AN EVALUATION OF THE HIGH ANGLE OF ATTACK

CONCEPTUAL DESIGN MODIFICATION FOR THE

NATIONAL TRANSONIC FACILITY

DECEMBER 1976

V-9 "COMPLETE POLAR" COST BREAKDOWN FOR ONE-DEGREE PER SECOND
CONTINUOUS SWEEP AND 8000 "COMPLETE POLARS"/YR.

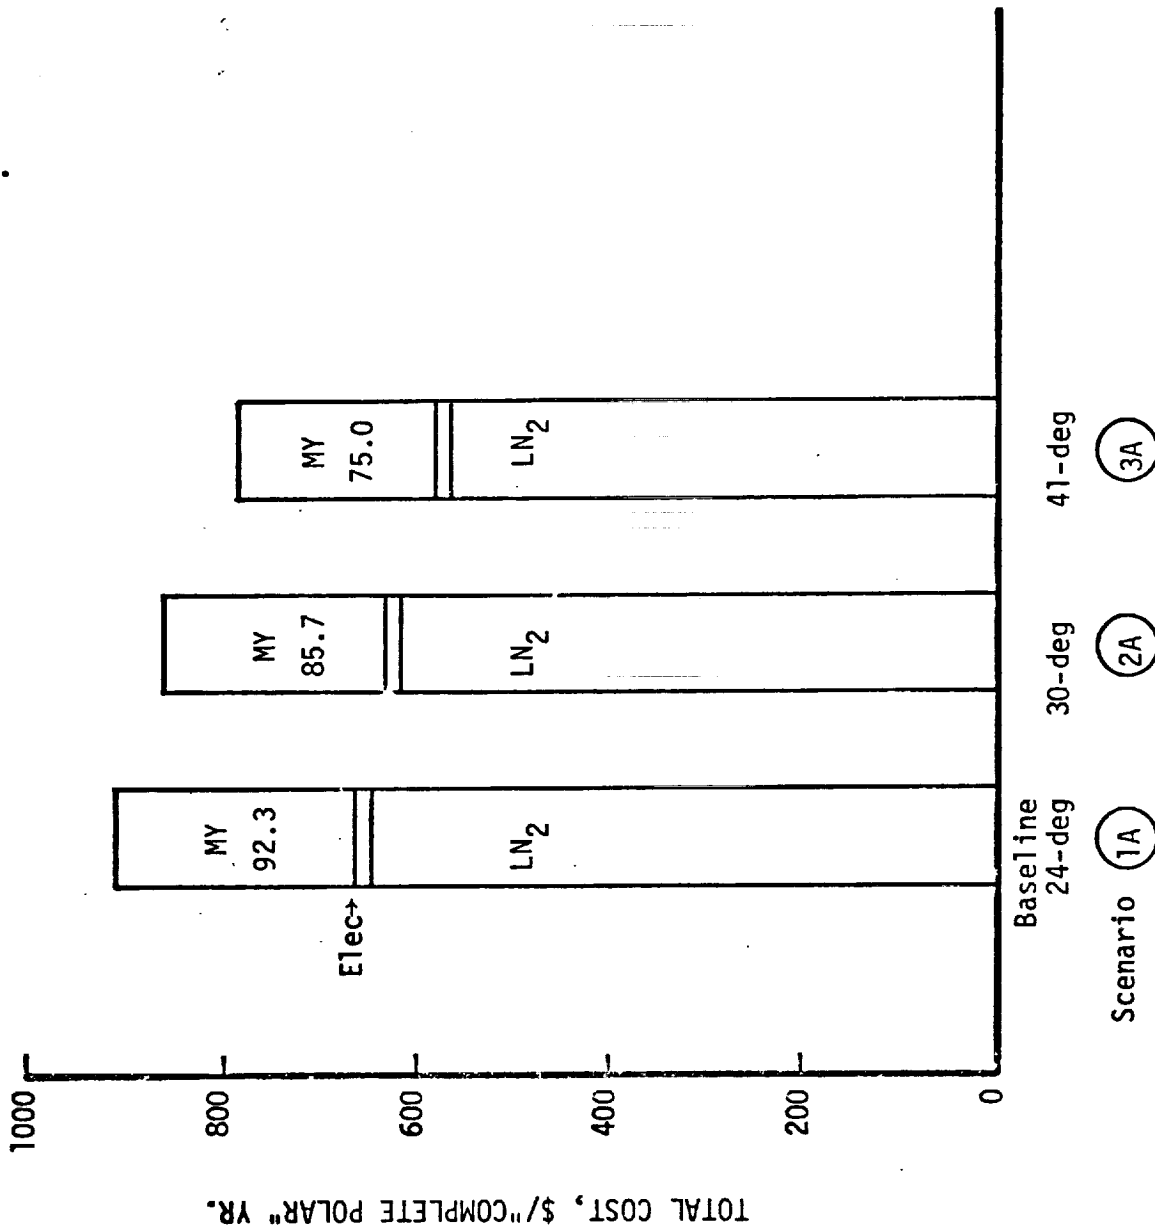
The resulting cost breakdown for the three configurations of the model support, is then as shown in V-9. Note the very small contribution of electrical energy and the overall reduction arising from the continuous sweep method of data acquisition.

V-10 Projected Annual Operating Cost Return Compared to the 24-Deg System for 8000 "Complete Polars"/Year

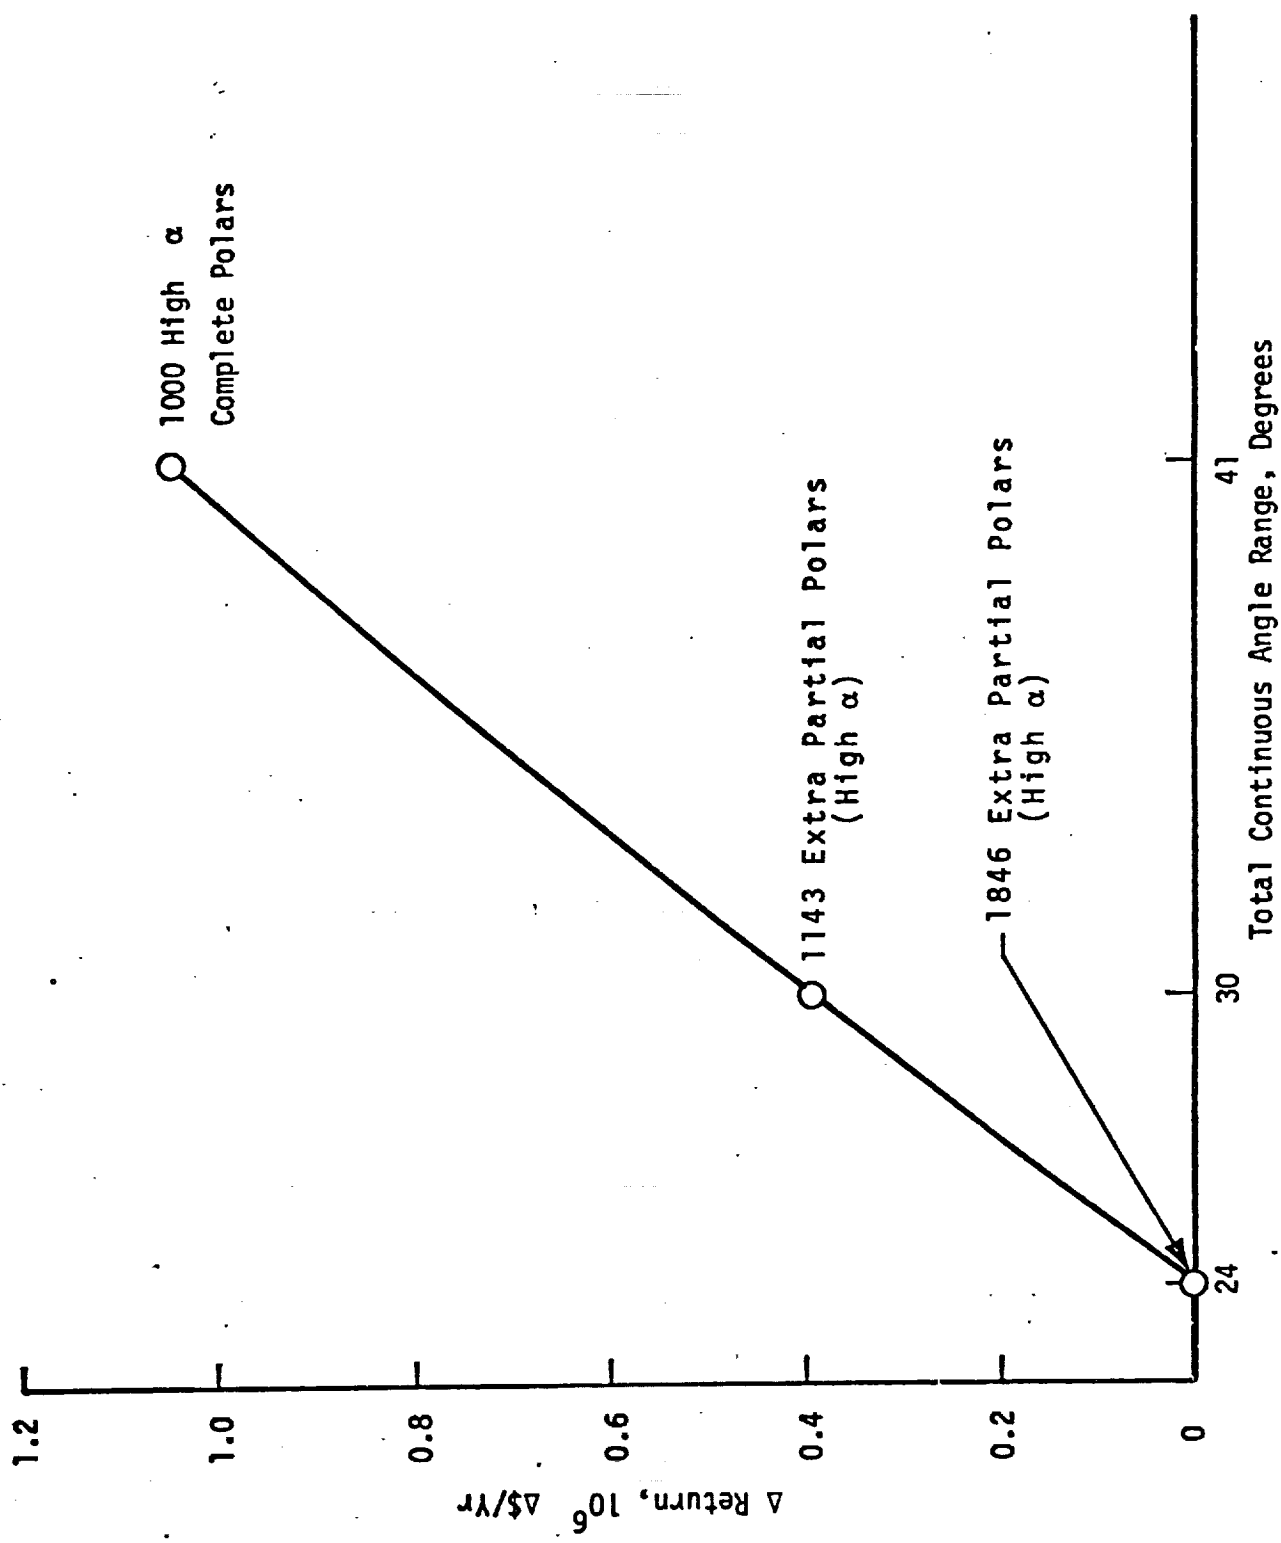
The cost saving or the annual delta dollars return for the two modifications as compared to the 24-degree system is as illustrated in V-10. If we neglect the compound interest value of money and capitalization, the years for each of the candidate systems to recoup the initial investment can be readily calculated as follows:
